**[EXTERNAL] Muskogee Community RDF - Tier III Permit Modification**

TIER III PERMIT MODIFICATION  
PUBLIC AND PRIVATE WATER WELLS

MUSKOGEE COMMUNITY RDF  
MUSKOGEE COUNTY, OKLAHOMA

FIGURE 10

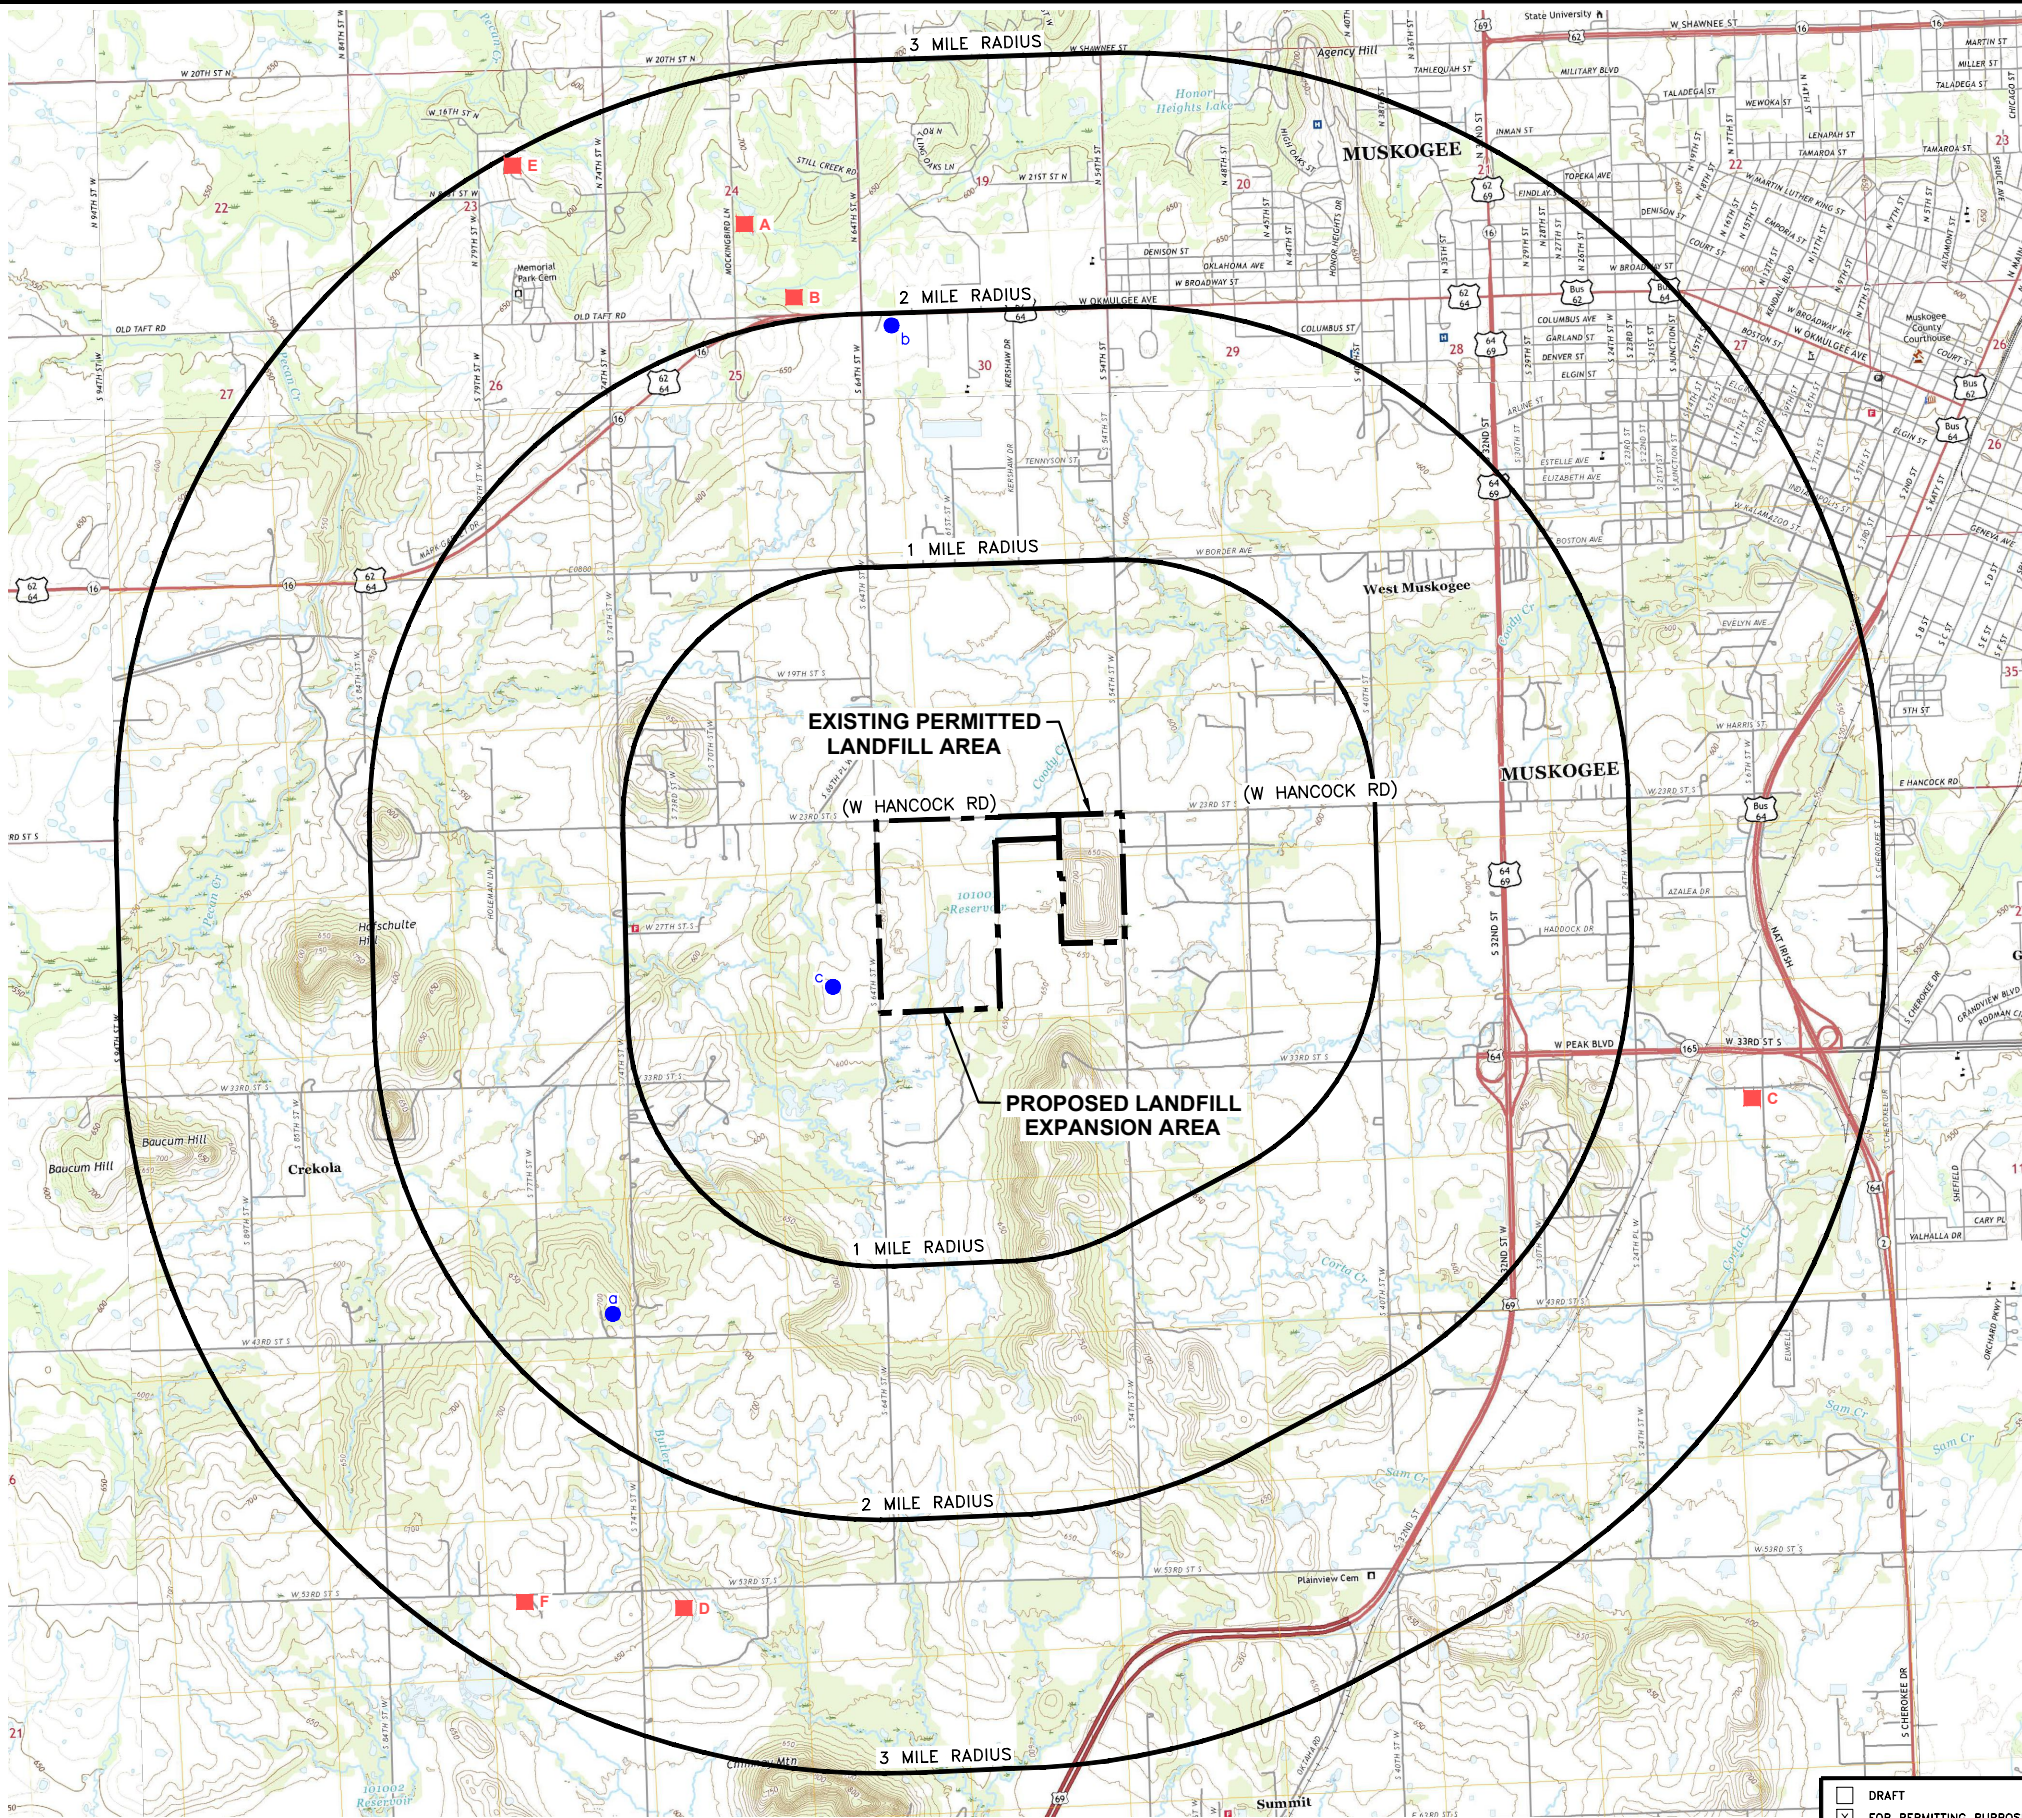
- Added Well c – This is the private well that was installed in April 2023 to the west of the site location. Information on Well c has been added to the table on the right side of the figure as well.

- Added Well E – This private well is located to the northwest of the site right at the 3-mile radius line. Based on the OWRB GIS system, it appears to be just outside the 3-mile radius, however, to be conservative given we were updating the dwg, we add Well E in. Information on Well E has been added to the table on the right side of the figure as well.

- Added Well F – This private well is located to the southwest of the site near the 3-mile radius line. Well F was installed in July 2025. Information on Well F has been added to the table on the right side of the figure as well.

- Note 3 – Note 3 was updated to reflect the October 2025 update.
- Note 5 – Note 5 was removed. The not indicated that no wells were located within 1-mile. Given the additional of Well c, this note was removed.

- Revision Note – A description of the revisions to the figure were added to the title block.

NO.	DATE	DESCRIPTION
1	10/2025	ADDED WELLS 22085, 237128, AND 47657 UPDATED NOTE 3, REMOVED NOTE 5
